**From:** Indra Boss <[iboss@ccc.tas.gov.au](mailto:iboss@ccc.tas.gov.au)>  
**Sent:** Monday, 29 April 2024 1:03 PM  
**To:** TPC Enquiry  
**Cc:** Mat Clark; Planning  
**Subject:** PDPSPAMEND-2021/019004 30 Holland Court, Howrah - Response to Directions of 4 April 2024.  
**Attachments:** PDPSPAMEND-2021-019004 Cover letter TPC post hear Direc Resp 29 Apr 24.pdf; Attach 1- PDPSPAMEND-2021-019004 Response to 4 April 2024 Direction Summary Table 29 April 2024.pdf; Attach 2 - CCC Marked up Revised Subdivision Plan -draft 0.3 29 April 2024.pdf; Attach 4 - Post Hearing Draft Permit - PDPSPAMEND-2021-019004 - 30 Holland Cort Howrah 29 April 2024.docx; Attach 5 - TPS - OPZ & UZChecklists 30 Holland Court 17 April 2024.pdf; Attach 3 -30 Holland Court - Proposed Subdivision original application Appendix B.pdf

**Tasmanian Planning Scheme – Clarence**  
**Draft amendment PDPSPAMEND-2021-019004 and combined permit**  
**30 Holland Court, Howrah**

Attachment 2 - CCC Response to TPC Directions of 4 April 2024

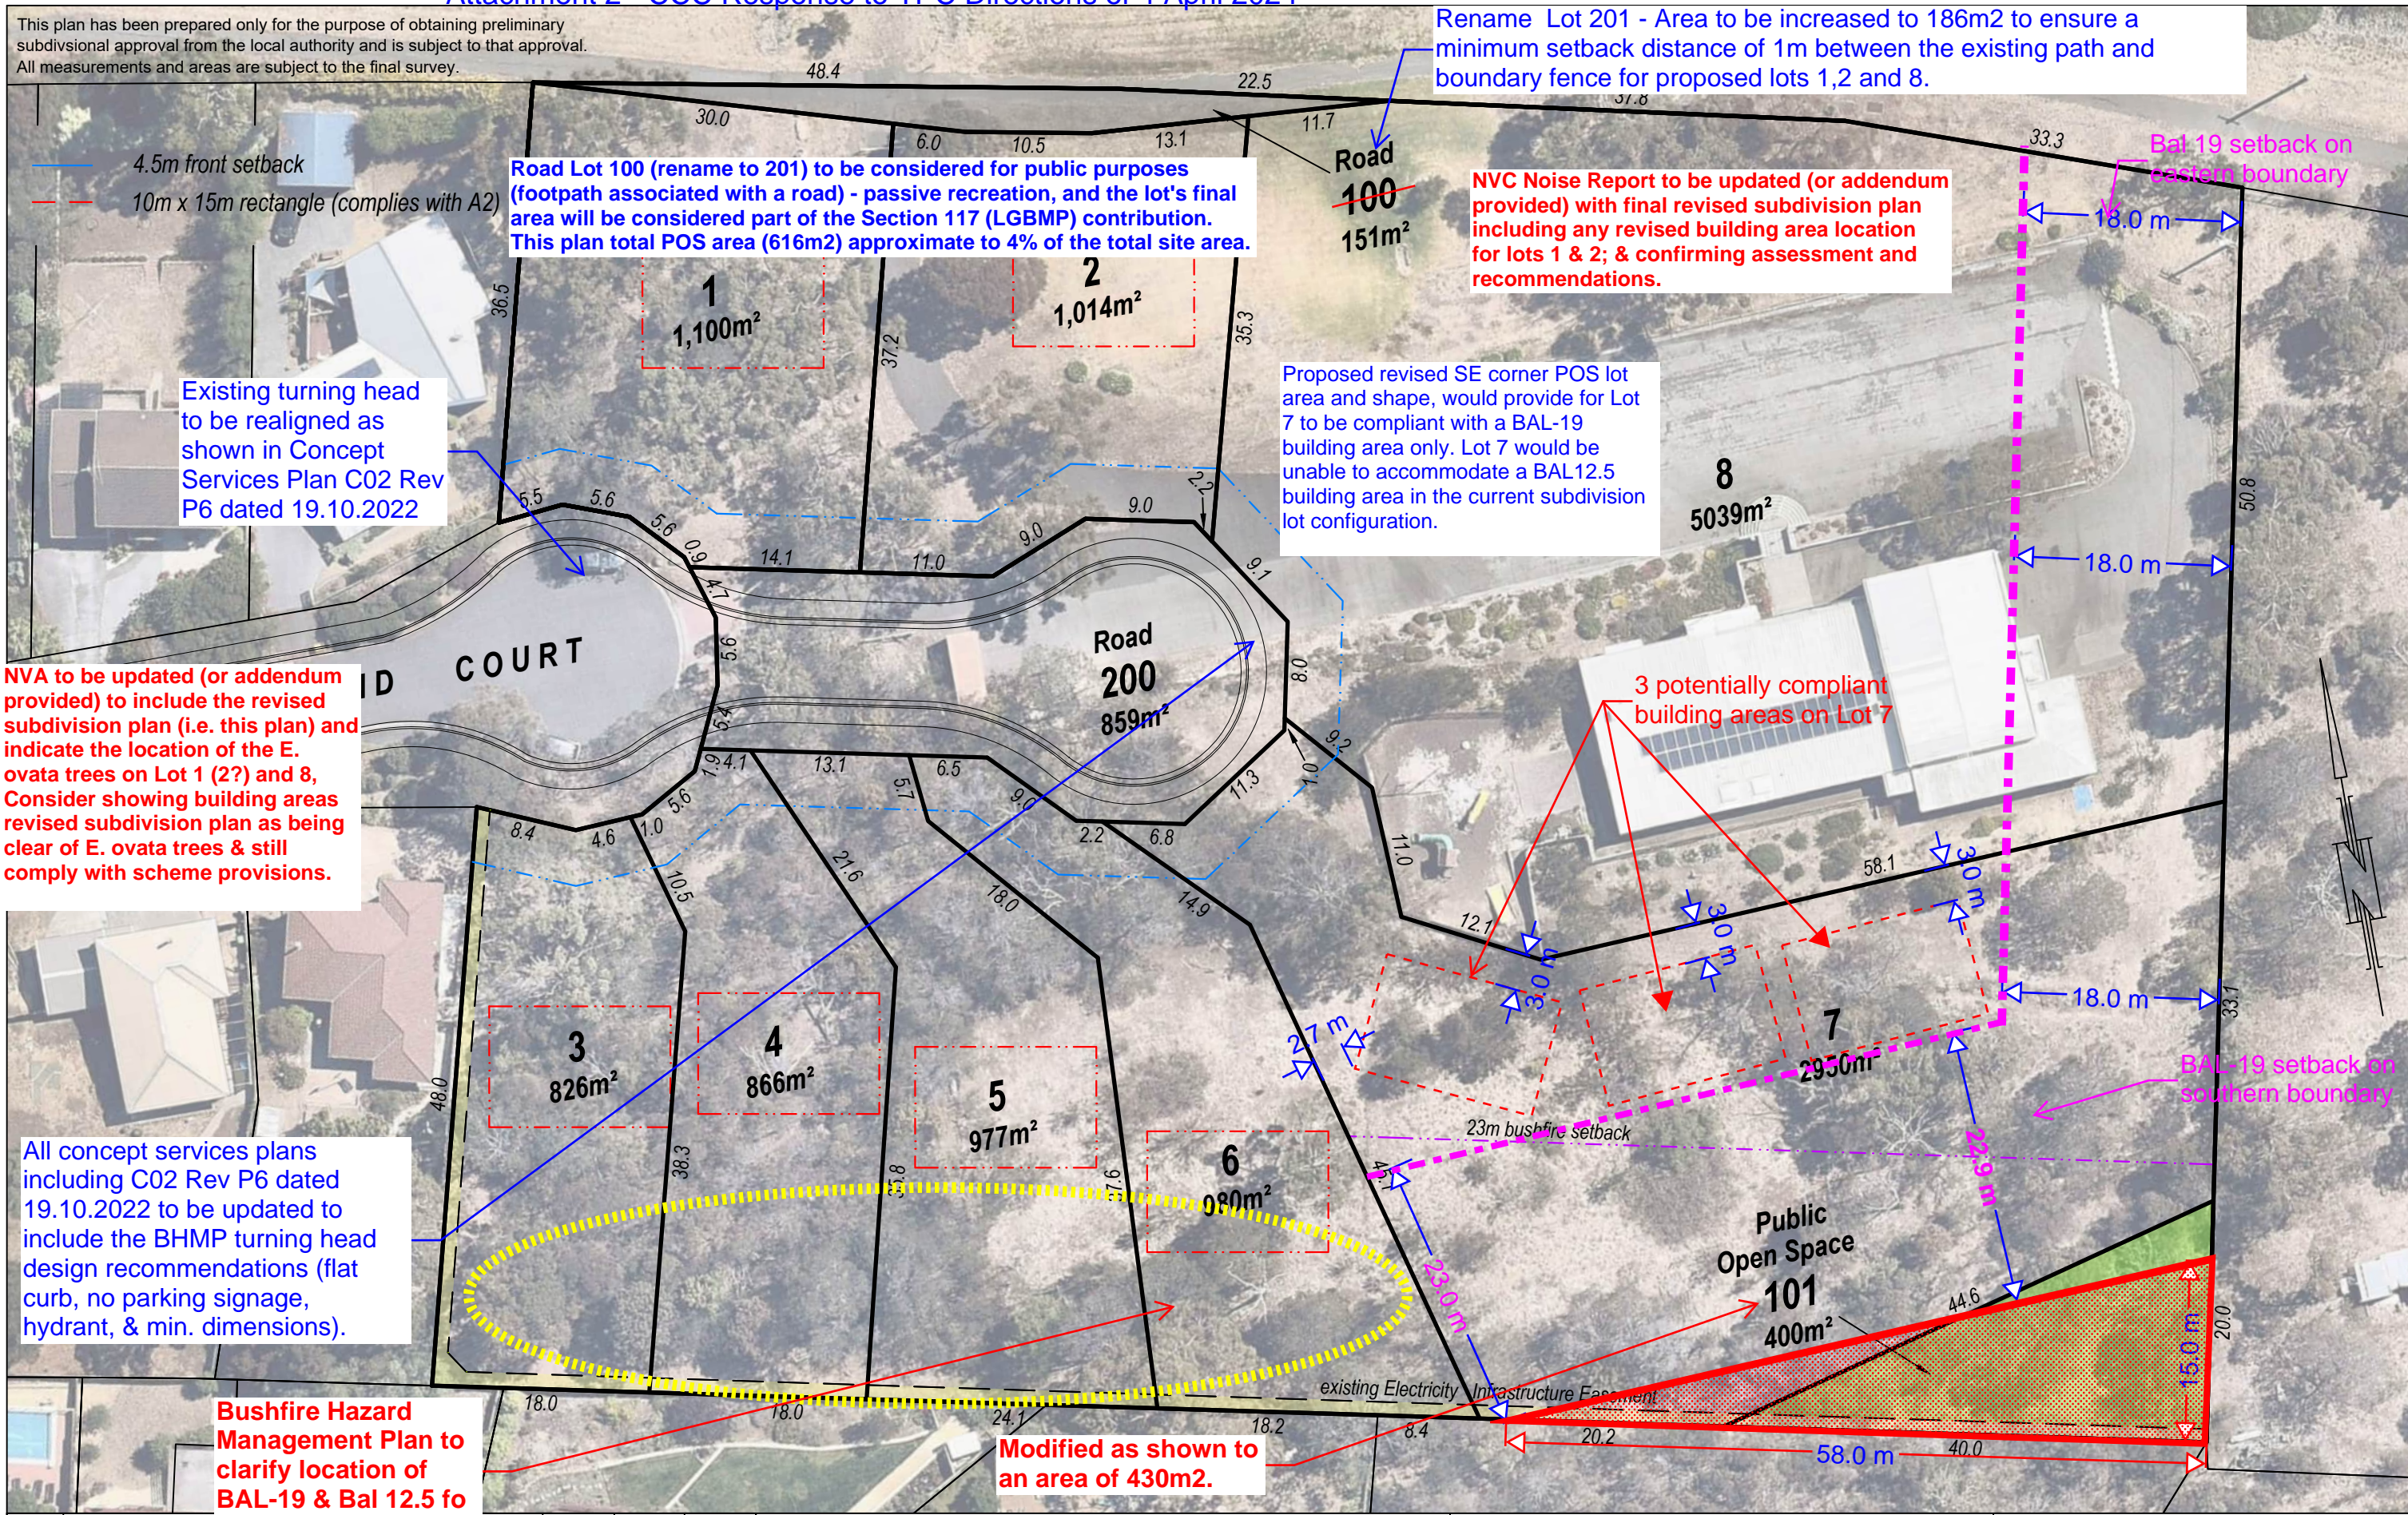
Following conversations with the applicant, it is our understanding that the attached information is generally agreed to – with matters to be resolved/updated identified in red text and/or highlighted in yellow. It is expected that the applicant will also provide confirming information/clarification today.

<ul style="list-style-type: none"> <li>• subdivision plan;</li> </ul>	<p>The changes described, are to be made to the applicant’s provided Proposed Subdivision Plan dated 12-08-2022 Revision J, see Attachment 3.</p> <p>(i) deletion of POS Lot 100;</p> <p>(ii) reconfiguration of the lot layout to incorporate Lot 100 into proposed subdivision lot 1</p> <p>(iii) modify proposed POS Lot 101 to extend from the south east corner along the southern boundary for a distance of 58m westward, and along the eastern boundary for distance of 15m northward, resulting in an area of land approximately 430m<sup>2</sup>; and</p>

TPC Direction – 4 April 2024	Council Response
	<p>(iv) show a new road lot (lot 201) along the northern boundary of the subject site to encompass the existing pedestrian path associated with the road lot to the north. Allowing for a minimum 1m setback between the existing pathway and the future northern lot boundaries of Lots 1, 2 and 8. The area of land is to be confirmed via the revised subdivision plan, but is estimated to be approximately 186m<sup>2</sup>.</p> <p>Refer Attachment 2.</p>
<ul style="list-style-type: none"> <li>concept services plan;</li> </ul>	<p>Updated concept services plan (JMG , Dwg Nos. C01 Rev P4 -21.09.2022, C02 rev P6 – 19.10.2022; C03 rev P4 -21.09.2022; C04 to C07 Rev P5 – 19.10.2022)</p> <p>(i) to show the revised subdivision plan as outlined in Attachment 2, and</p> <p>(ii) to show the Bushfire Hazard Management Plan (BHMP) performance solution design for the cul-de-sac, as detailed in a revised Tasmanian Fire Service approved BHMP</p>
